**APPROVED BY  
CITY COUNCIL ACTION**  
**ORDINANCE #** 2129  
**Date:** 8/1/23

ISSUE DATE:  
July 25, 2023

Re: Center Stage Planned Development  
Keller, Texas

## **Changes from March 12, 2020 draft**

**FIGURE 4.1  
STREET PLAN**

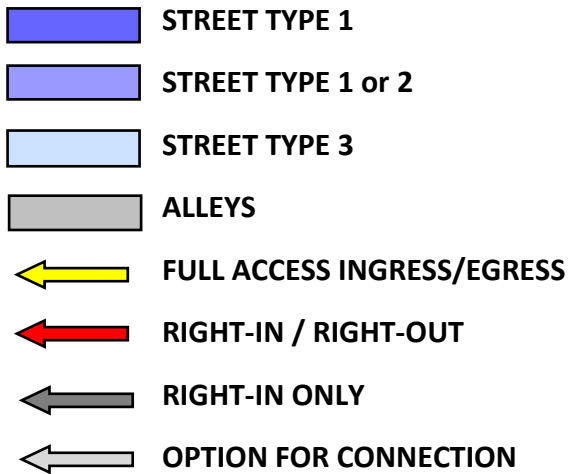
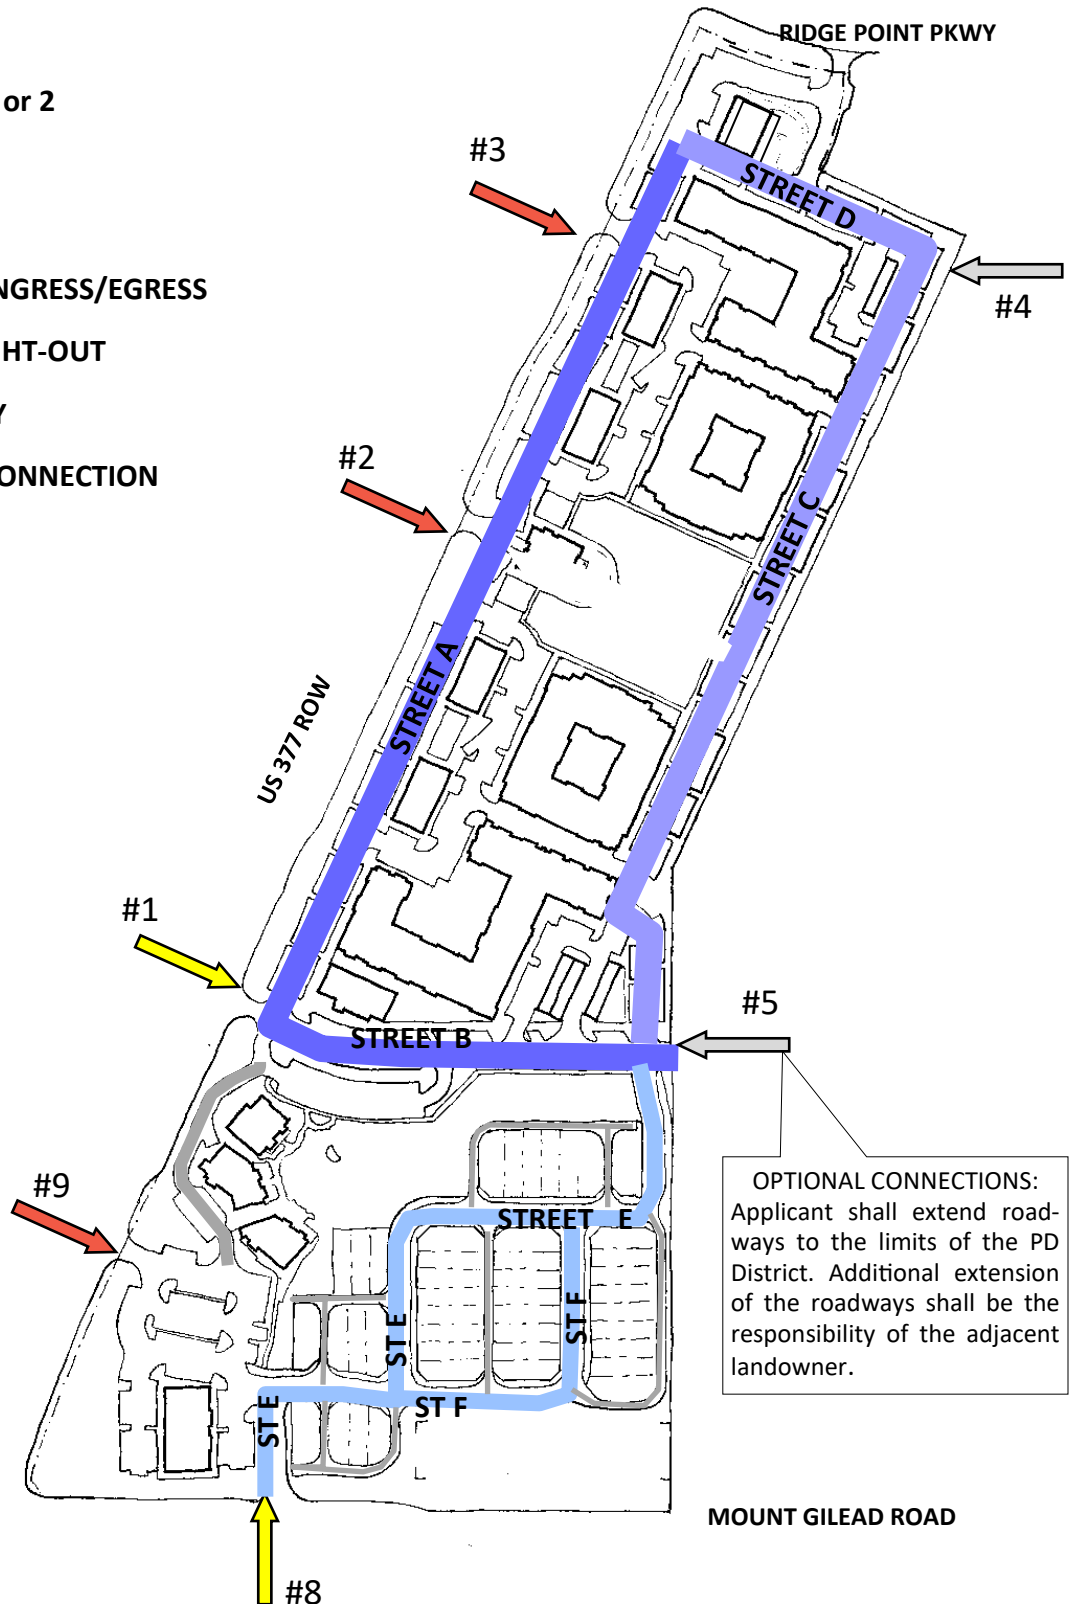
(P16): Updated Note 4 to remove reference to Streets F&G, updated Figure 4.1

**NOTE 4:** Dead end streets shall be provided with a Cul-de-sac, ROW diameter 120' and paved diameter 100'. This would apply to the southern ends of Streets E, F and G if they terminate in a dead end.

**FIGURE 5.1  
OPEN SPACE PLAN**

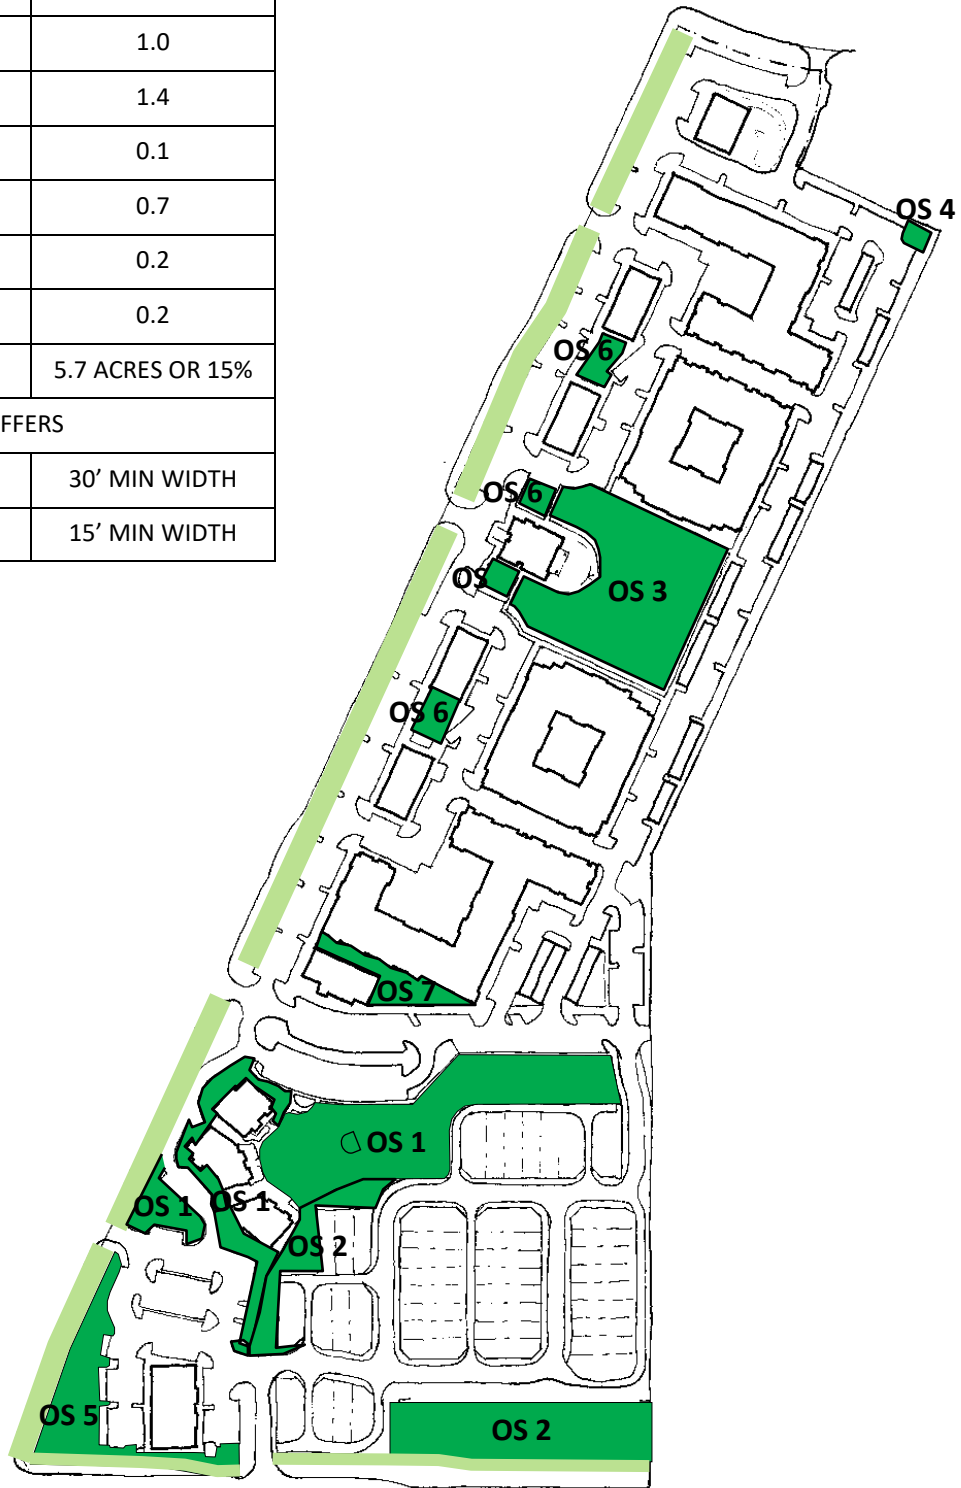
(P22): updated figure 5.1 and table 5.1 to remove Linear Park OS 8 and incorporate its 0.2 acre minimum into OS 1, illustrate OS 3's current configuration (its as-built condition exceeds the minimum 1.4 acre open space) and show the required buffer yard along 377 (30') and Mt Gilead (15')

**FIGURE 5.3  
PEDESTRIAN NETWORK**

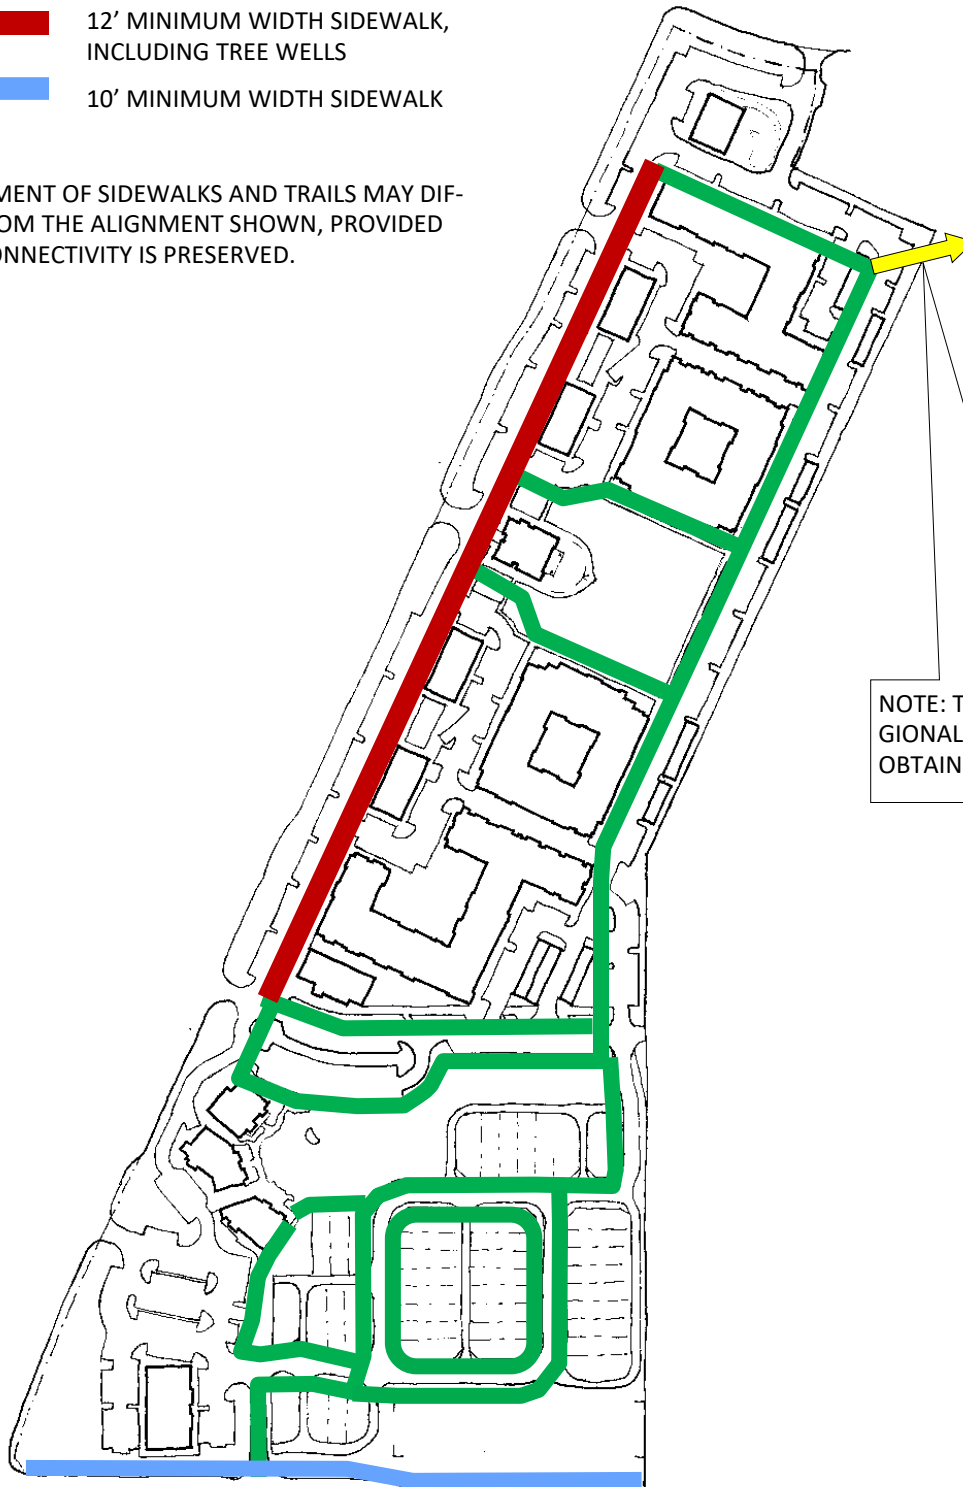
(P25): updated figure 5.3
